**Re: Citizen Complaint of Casey Voigt**

### INSPECTION REPORT

PERMITTEE - MINE: Coyote Creek Mining Company, L.L.C. - Coyote Creek Mine

PERMITS INSPECTED: NACC-1301 and NACC-1302

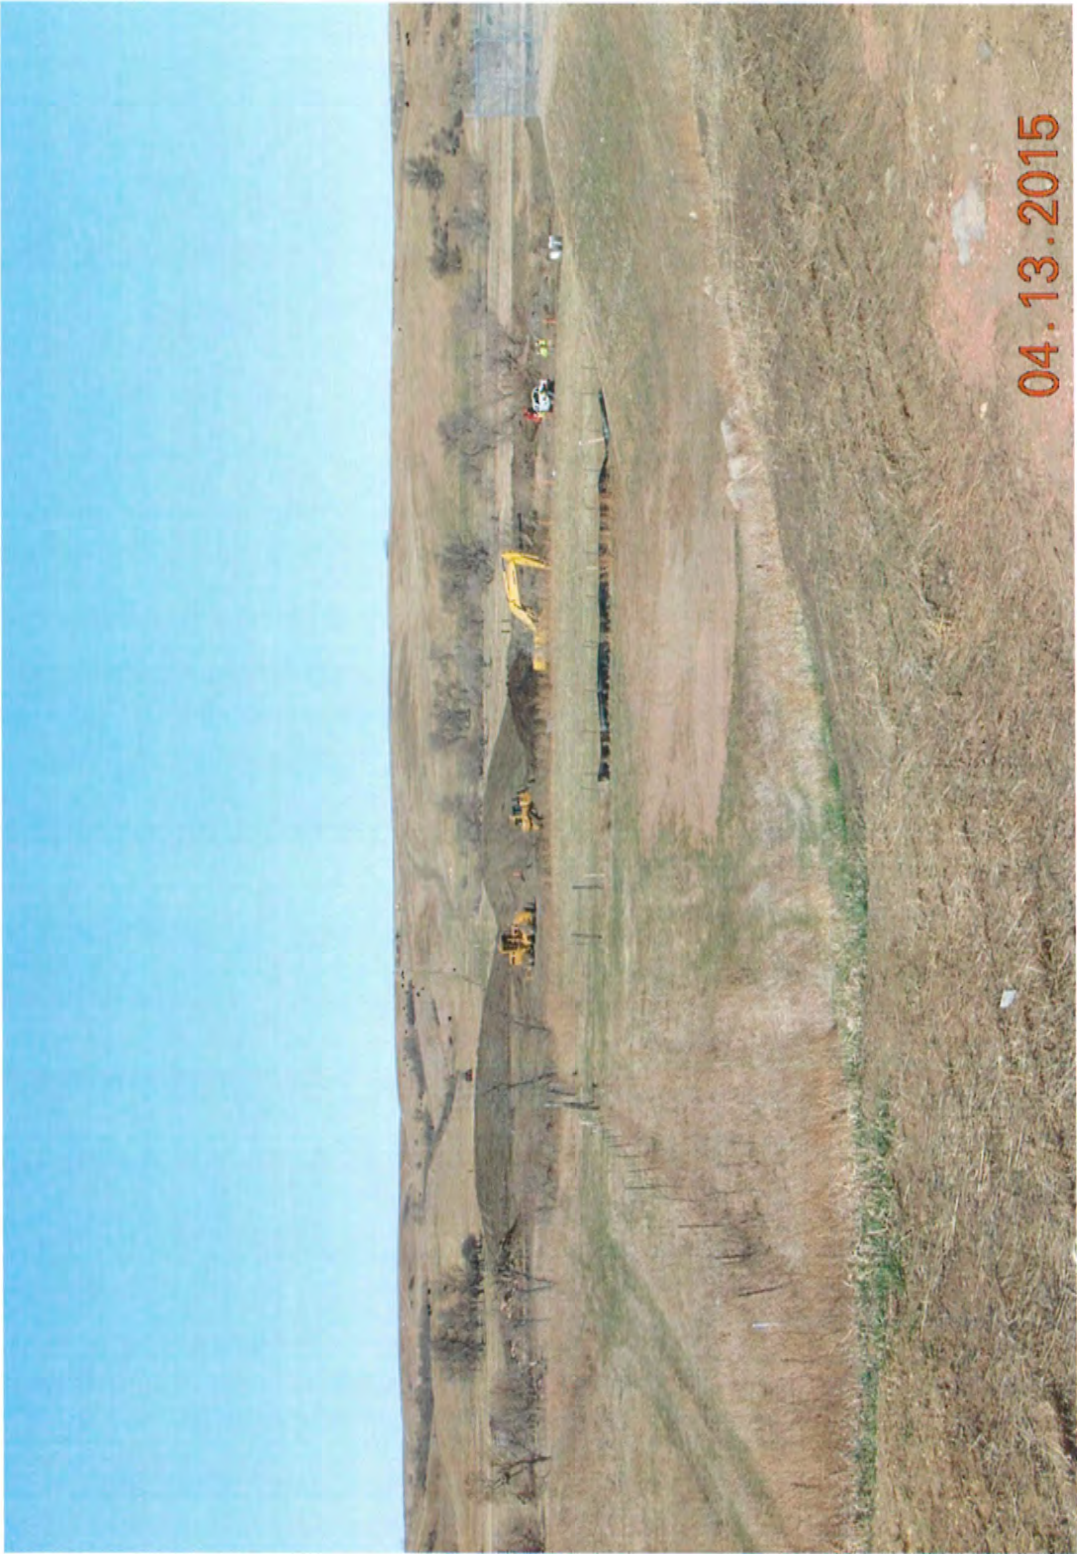
Culvert installation for the Shop Access Road Coyote Creek crossings was also viewed while viewing SPGM removal for a four acre segment of the Shop Access Road on both sides of Coyote Creek as previously described. At the time of inspection, the 36 inch low flow steel culvert was being installed as pictured in Figure 4. It should be noted that the approved design for the 36 inch culvert depicts a slight angle near the culvert's midpoint. The design was revised to depict a straight culvert with the application of Revision No. 1 to Permit NACC-1302 that is under review. The proposed design change was approved by the commission via email correspondence on March 19, 2015 and it received U.S. Army Corps of Engineers concurrence on March 20, 2015. Please refer to Figure 5 for the culvert types and locations for the Shop Access Road Coyote Creek crossings. Installation of the 36 inch low flow steel culvert would need to be completed no later than April 14<sup>th</sup> because CCMC's Regional General Permit from the U.S. Army Corps of Engineers does not allow regulated activity in Coyote Creek from April 15<sup>th</sup> to June 1<sup>st</sup>. Installation of the four 10 foot by 10 foot box culverts will follow but it appears that they will not be installed to divert Coyote Creek flow until after June 1<sup>st</sup>. Mr. Steffen indicated SPGM removal will proceed westward along the Shop Access Road corridor toward the location for pond P31-01 after the 36 inch low flow steel culvert installation is complete. Overburden from pond P31-01 excavation will provide the fill necessary to achieve grade for the Shop Access Road.

Upon returning to the mine office-shop facility near the close of the inspection the Reclamation Division inspectors informed CCMC personnel that the sequence of Shop Access Road Coyote Creek crossing culvert installations appears to be the reverse order of that approved in Permit NACC-1302. As described in the permit, the culvert crossings would proceed eastward in conjunction with excavation of pond P31-01 with installation of the four 10 foot by 10 foot box culverts first followed by installation of the 36 inch low flow steel culvert. Excerpts from Permit NACC-1302 relevant to the Shop Access Road Coyote Creek crossing culvert installations are as follows:

Based on the foregoing permit excerpts and observations from the April 13, 2015 inspection, it appears that CCMC is conducting operations for the Shop Access Road Coyote Creek culvert installations in reverse order of that approved in Permit NACC-1302. CCMC should have requested commission approval to revise culvert installation plans and provided adequate justification for doing so. Furthermore, it appears that potentially serious environmental risks are posed by installing the low flow culvert prior to diverting Coyote Creek flow through the box culverts. The Coyote Creek stream flow is now restricted through the low flow culvert until the box culverts are installed to divert the stream presumably after June 1<sup>st</sup>. High stream flow resulting from a heavy precipitation event may overtop the low flow culvert and cut through culvert backfill and the Shop Access Road corridor causing downstream sediment deposition. CCMC is advised to expedite box culvert installation so Coyote Creek flow can be diverted through the box culverts immediately after the U.S. Army Corps of Engineers spring restriction of regulated activity expires. CCMC is also advised to refrain from building any segment of the Shop Access Road near Coyote Creek that could function as an embankment and cause upstream flooding if stream flow is restricted by the low flow culvert.
